### **Proposal for Supplement 13 to the 04 series of amendments to UN Regulation No. 44 (Child Restraint Systems)**

#### **Submitted by the Working Party on Passive Safety\***

## **Proposal for Supplement 13 to the 08 series of amendments to UN Regulation No. 44 (Child Restraint Systems)**

Figures of Strapped child

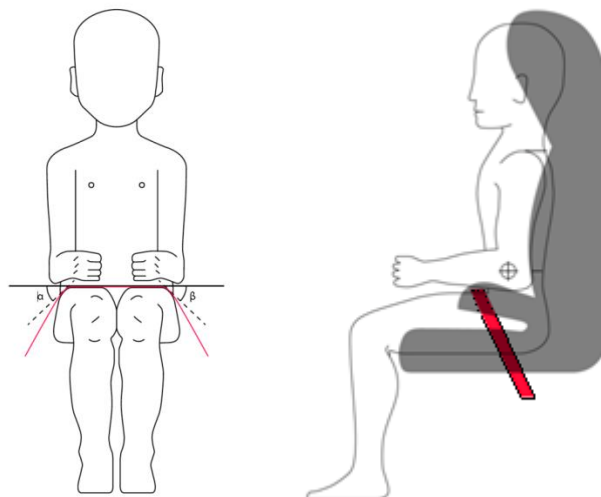
*Paragraph 6.2.2.*, amend to read:

- "6.2.2. All restraint devices utilizing a "lap strap" shall positively guide the "lap strap" on both sides to ensure that the loads transmitted by the "lap strap" are transmitted through the pelvis. The assembly shall not subject weak parts of the child's body (abdomen, crotch, etc.) to excessive stresses.

In the case of booster cushions and booster seats , the lap portion of the adult seat belt shall be positively guided on both sides to ensure that the loads are transmitted by the adult lap belt are transmitted through the pelvis. The positive guidance of loads over the pelvis shall be realised from the moment that the child is installed; the lap belt shall pass over the top of the thigh, just touching the fold with the pelvis. The angles  $\alpha$  and  $\beta$  between the tangent line in which the belt touches the thighs and the horizontal shall be greater than  $10^\circ$ .
